ADDENDUM NO. 03

Northland Corridor Redevelopment Project Phase 4
631 Northland Ave.
Buffalo, NY 14211

Project No. 432607

Project Northland Corridor Redevelopment Phase 4 (BUDC) Addendum No. 3
631 Northland Avenue, Buffalo, NY Contract -
Wendel Project No. 432607 Date 10/22/25

6 SECTION DETAIL - FIXED WINDOW
SCALE: 1 1/2\"/>

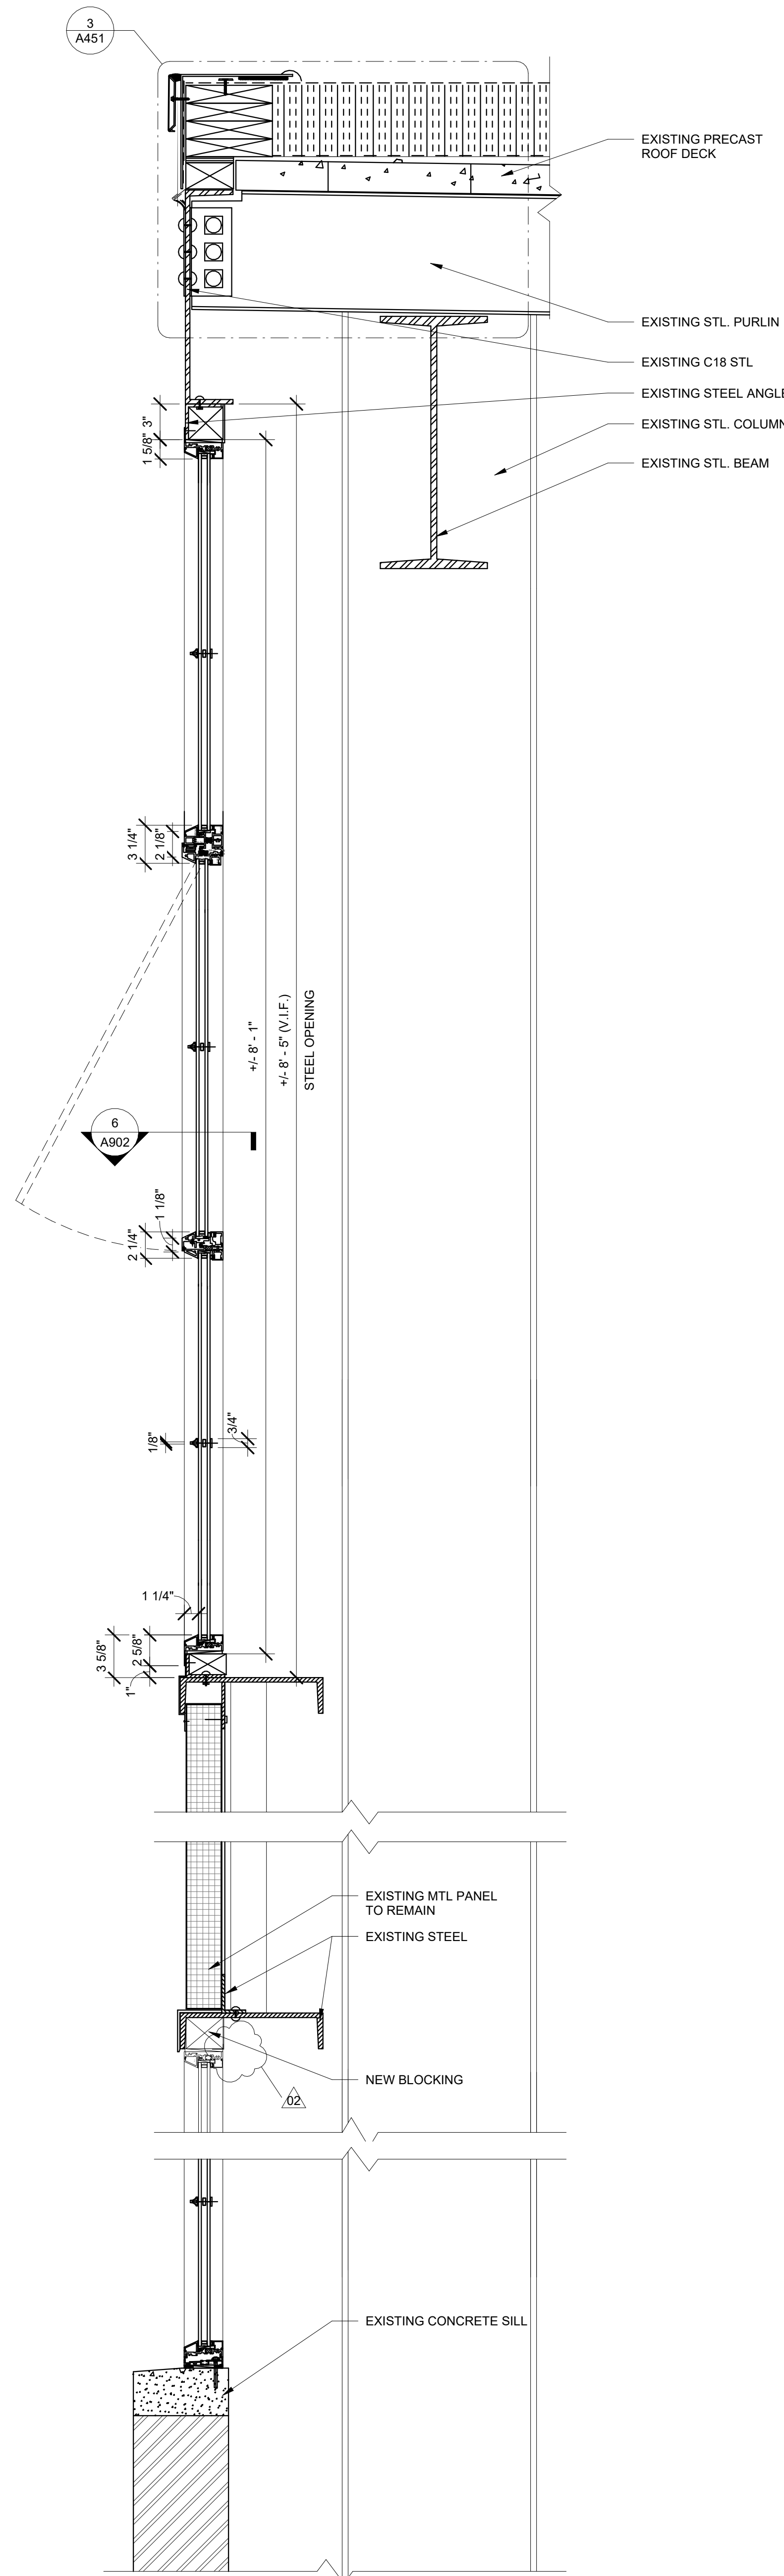
1. Door hardware is in Section 087100 which was inadvertently omitted from the original spec. Refer to specification Section 087100 attached to this addendum.
2. Drawing sheets A301 and A900 were revised and issued under Addendum 02.
3. Please refer to window elevations and coordinate with schedule. Please ask specific questions if contractor(s) are unclear on anything further.
4. Refer to revised drawing A901 removing snap trim from windows. There should be no snap trim.
5. Refer to revised drawing A901. SHPO & NPS final approval on windows are pending the window mockup in process. Contractor and awarded window manufacturer are responsible for verifying in field and confirming details via shop drawings. Design intent is that windows shall receive wood blocking where the head and/or sill have steel angles present.

REPLACE: Drawing sheet A901 with the revised issued in this addendum.
